Informal document GRSP-59-08-Rev.1  
(59th GRSP, 9-13 May 2016,  
agenda item 19)

## **Proposal for the 02 series of amendments to Phase 2 of Regulation No. 129 (Enhanced Child Restraint Systems)**

**Submitted by the expert from France,**

Figure 1: Load cell positions

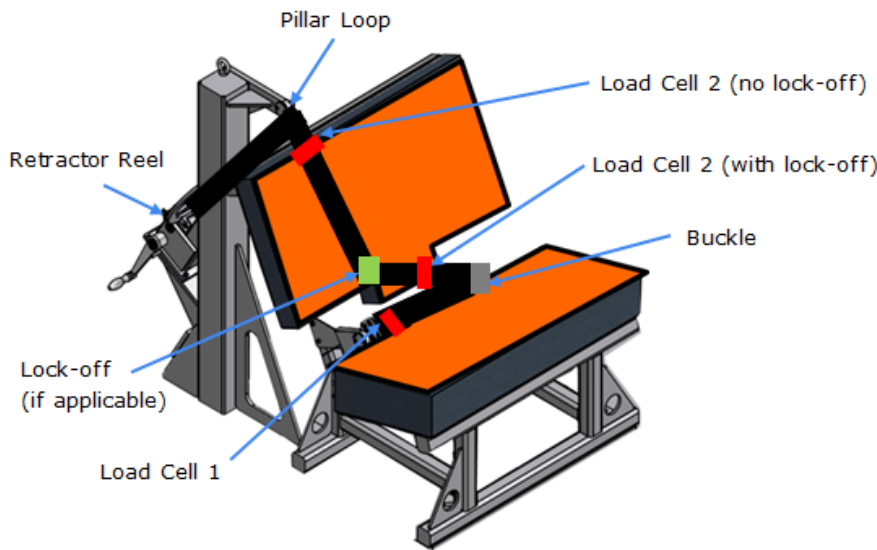
Fit load cell 1 to the outboard position as shown Figure 1. Install the Enhanced Child Restraint System in the correct position. If a lock-off device is fitted to the Enhanced Child Restraint System and acts upon the diagonal belt, place load cell 2 at a convenient position behind the Enhanced Child Restraint System between the lock-off device and the buckle as shown above. If no lock-off device is fitted or if the lock-off device is fitted at the buckle, position the load cell at a convenient position between the pillar loop and the Enhanced Child Restraint System.

Adjust the lap portion of the reference belt to achieve a tension load of  $50 \text{ N} \pm 5 \text{ N}$  at load cell 1. Make a chalk mark on the webbing where it passes through the simulated buckle.

While maintaining the belt at this position, adjust the diagonal to achieve a tension of  $50 \text{ N} \pm 5 \text{ N}$  at load cell 2 by either locking the webbing at the Enhanced Child Restraint System webbing locker or by pulling the belt between the belt clamping mechanism and the standard retractor. If the tension in load cell 2 is achieved by pulling the belt between the clamping mechanism and the retractor, the clamping mechanism shall now be locked.

Figure 1

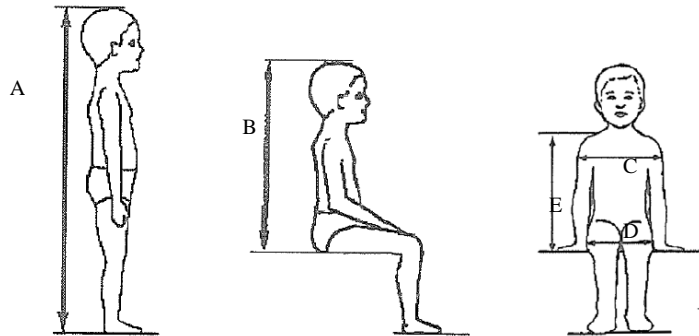
Stature cm	Minimum Sitting height cm	Minimum Shoulder breadth cm	Minimum Hip breadth cm	Minimum Shoulder height cm	Maximum Shoulder height cm
A	B	C	D	E1	E2
	95%ile	95%ile	95%ile	5%ile	95%ile
<del>40</del>				<del>27.4</del>	
45	39.0	12.1	14.2	27.4	29.0
50	40.5	14.1	14.8	27.6	29.2
55	42.0	16.1	15.4	27.8	29.4
60	43.5	18.1	16.0	28.0	29.6
65	45.0	20.1	17.2	28.2	29.8
70	47.1	22.1	18.4	28.3	30.0
75	49.2	24.1	19.6	28.4	31.3
80	51.3	26.1	20.8	29.2	32.6
85	53.4	26.9	22.0	30.0	33.9
90	55.5	27.7	22.5	30.8	35.2
95	57.6	28.5	23.0	31.6	36.5
100	59.7	29.3	23.5	32.4	37.8
105	61.8	30.1	24.9	33.2	39.1
110	63.9	30.9	26.3	34.0	40.4
115	66.0	32.1	27.7	35.5	41.7
120	68.1	33.3	29.1	37.0	43.0
125	70.2	<del>34.5</del> 33.3	<del>30.5</del> 29.1	38.5	44.3

Figure 1  
Standard seat belt configurations

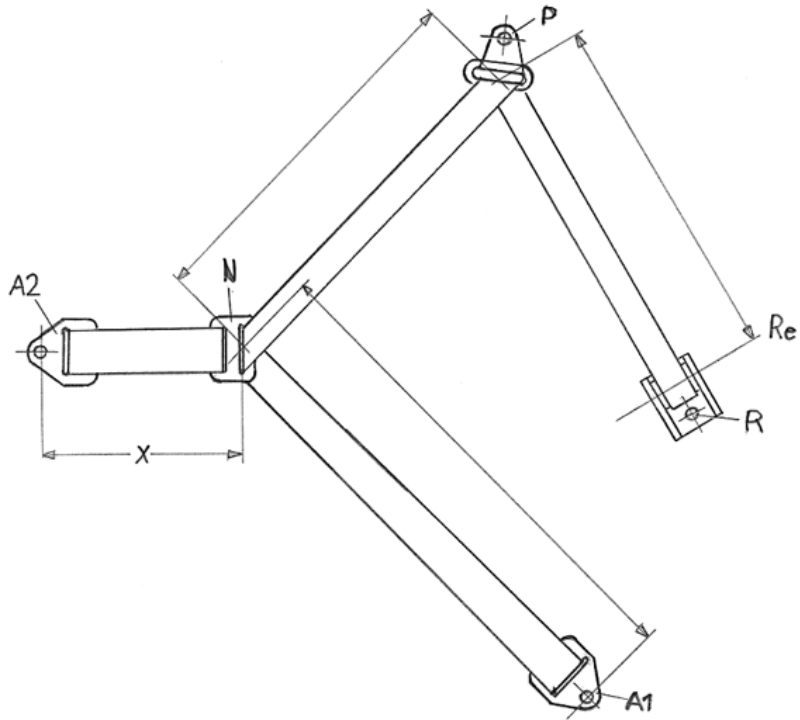
1. The safety-belt for the dynamic test and for the maximum length requirements shall be made according to the configuration shown in Figure 1. These are a three-point retracting belt system.

The value of X in Figure 1 below is  $200 \pm 5$  mm. The effective strap length between A1 and the centre line of the retractor spool Re (when the webbing is fully extracted including the minimum length of 150 mm for testing of Enhanced Child Restraint System shall be  $[2820] \pm 5$  mm when measured in a straight line without load and on a horizontal surface. This length may be increased for the testing of restricted categories; for all categories with the Enhanced Child Restraint System installed, there shall be a minimum of 150 mm of strap length on the retractor spool.
